**ADDENDUM #3 – December 6, 2024**

Re: Request for Proposals  
Public-Private Partnership for a New Student Housing Project  
Middle Tennessee State University  
SBC Project No. 366/000-01-2024

From: Middle Tennessee State University  
1301 E. Main St., Box 44  
Murfreesboro, TN 37132

This Addendum consists of seven (9) pages plus a (93) page Geo-technical Report and covers the following topics: The two 2-bedroom staff beds, new attachments, Pre-Development Agreement (PDA), and RFP Step 2 Questions & Responses.

# Rec Center Conceptual Plan

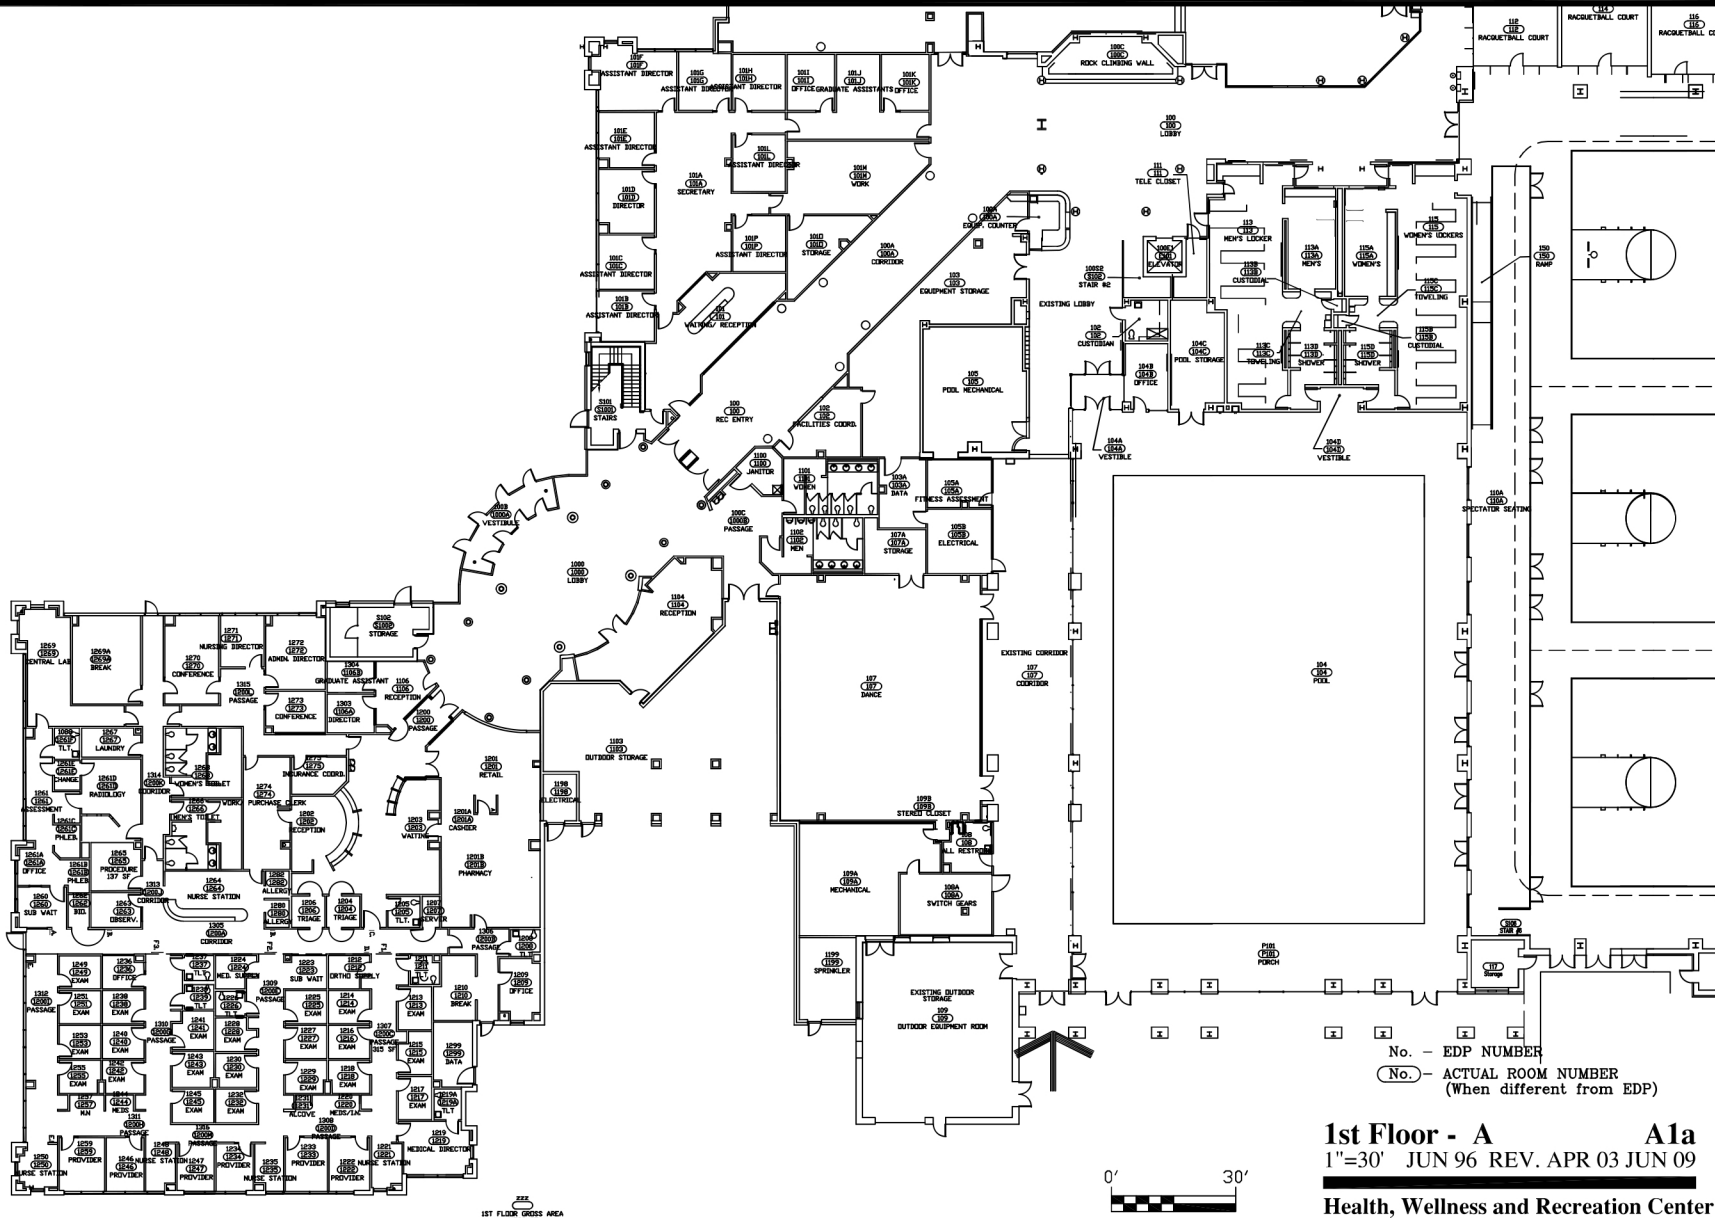
South entrance to the Rec Center will remain in the existing location. Proposed work includes renovations to make south entrance more accessible and inviting. This work may include the removal of exterior masonry wall and improvements to hardscapes and sidewalks to provide convenient and accessible access to the south. See the attached file for the Rec Center's floorplan.

Existing wall removed

New entry plaza
